VARIAN 620/L-100
MAINTENANCE MANUAL

ENGINEERING NOTICE

E.N. No. 83017

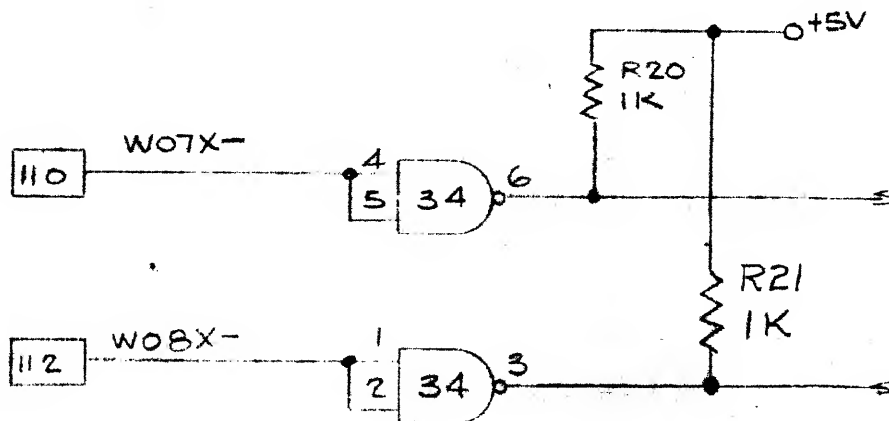
REASON FOR ACTION OUTPUT CWIX - (IC34-11) IS OR-TIED ON GROUND PLANE WITH A DTL OUTPUT OF PFR BOARD. DRIVING GATES MUST BE OPEN-COLLECTOR OR DTL. DTL GATE ON PFR UNABLE TO PULL DOWN ACTIVE PULLUP GATE ON INTERRUPT TRAP BOARD RELIABLY.	CHANGE CODE: <u>1</u> OUTSTANDING CODE 2 EN S: <u>C</u>
---	---

1. SHEET 1 REFERENCE DESIGNATION BLOCK
LAST USED IS: R22 WAS: R19
2. SHEET 2 ZONE B4 ADD R20 & R21 AS SHOWN

3. SHEET 3 ZONE B7 ADD R22 AS SHOWN

1. REMOVE IC 34 (49A0039-000) AND REPLACE IC 34 USING 49A0042-000 (74H01)
2. ADD 3 RESISTORS 1K, $\frac{1}{4}W$, $\pm 5\%$ (65N2500-102) AS SHOWN.

SECTION B-B
EXPLODED VIEW (TYP FOR CR1-CR4, Q1)

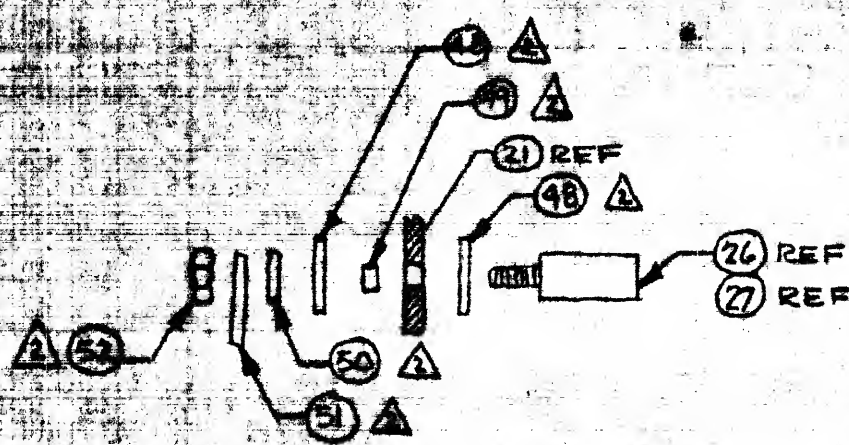
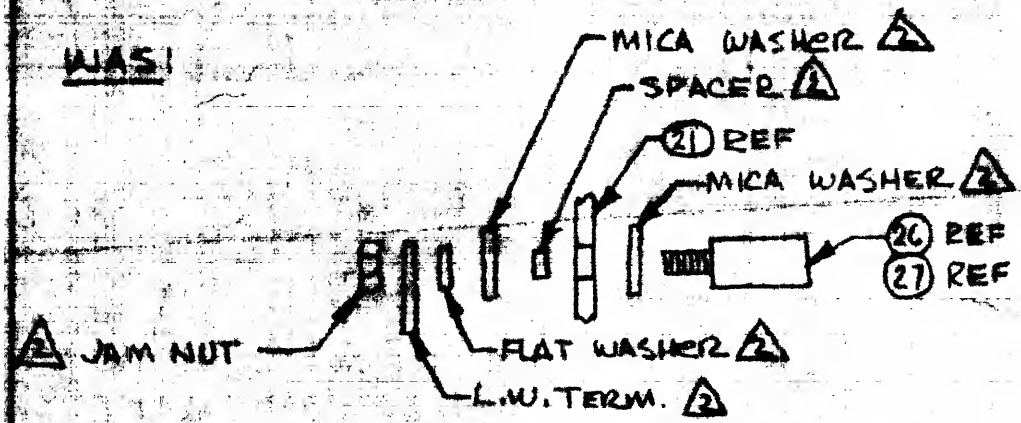
1. TO ADD NON-STANDARD HARDWARE REQUIREMENTS
2. TO REVISE HARDWARE CALLOUT
3. TO ELIMINATE POSSIBLE SHORTING OF HDW. TO HEATSINK
4. TO ADD MTG BRACKETS TO P.S. PARTS LIST

1) REVISE SECTION B-B AS SHOWN BELOW

SECTION B-B
EXPLODED VIEW (TYP FOR CR1-CR4, Q1)
USE MT6 KIT F/N 45 FOR Q1

4000506 - CONT'D

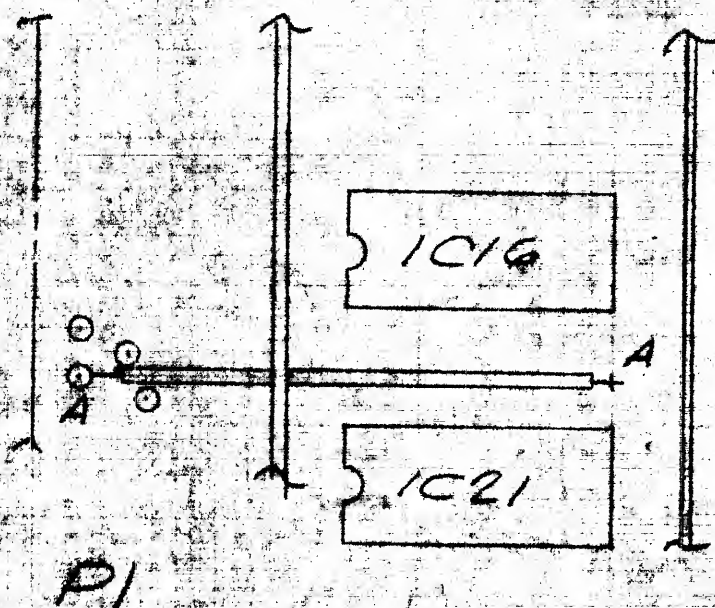
1. TO REMOVE JUMPER A-A

1. REMOVE ETCH FROM PI-59 TO FEEDTHRU A
2. REMOVE ETCH FROM IC16-7 TO FEED THRU A
3. ADD ETCH FROM PI-59 TO IC16-7.

2. HOLE CHART, REVISE QTY FOR SYM A
IS 1230, WAS: 1232

91DO360-LOGIC-PROC. CONTROL N22

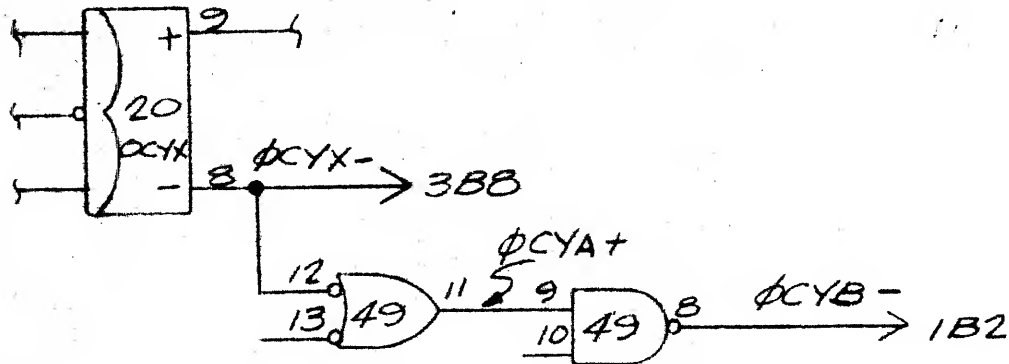
REASON FOR ACTION <u>TO ENABLE THE 620L-100 TO PASS INSTRUCTION TEST NO. 2 BY ELIMINATING A DECODING SPIKE ON IAPX+</u>	CHANGE CODE <u>1</u>
	OUTSTANDING CODE <u>ENS</u>

1. SHEET 1, ZONE C1, REVISE AS FOLLOWS:
